# **FREDERICK COUNTY PLANNING COMMISSION**

**TITLE:** Talbot Ridge Farm, Section 3, Lots 4-8

**FILE NUMBER:** S-1087, AP 15294 (APFO 15295, FRO 15296)

**REQUEST:** **Combined Preliminary/Final Plat**  
The Applicant is requesting combined preliminary/final approval for a 5-lot Agricultural Cluster subdivision on a 250.59-acre property.

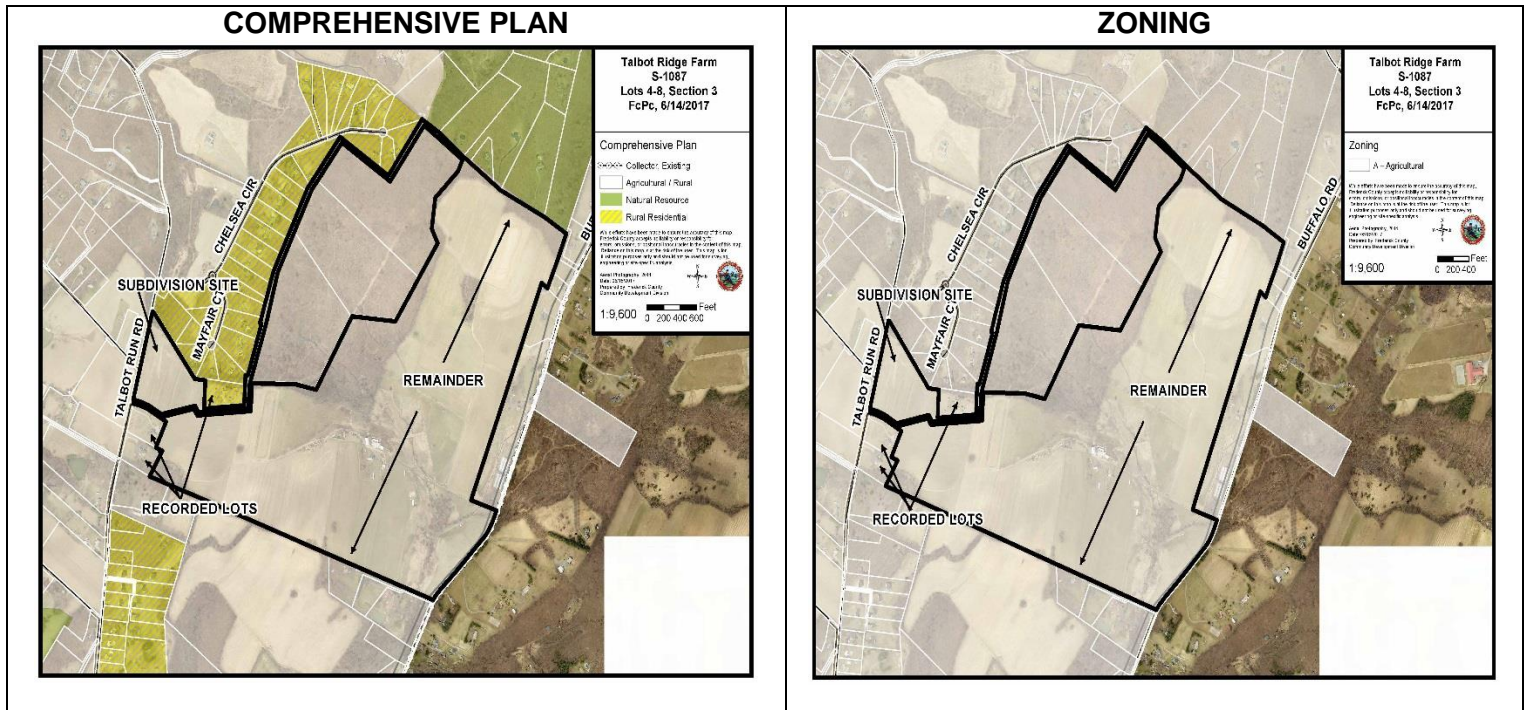
The proposed five-lot subdivision is situated along Talbot Run Road, adjacent to an existing 32-lot subdivision (Talbot Run Estates). Most of the 250 acre property consists of Class II and III prime agricultural soils (Class II= GhB, Class III= GgB, GhC, & MeC). Proposed Lots 4, 5, and 8 are within Class II soils, and Lots 6 and 7 are situated within Class III soils. The other areas of the property with adequate road frontage for subdivision also consist of Class II and III soils, therefore avoiding these soils is not feasible. The proposed lots are situated adjacent to existing development and existing residential zoning, providing for the most desirable location on the farm for subdivision.
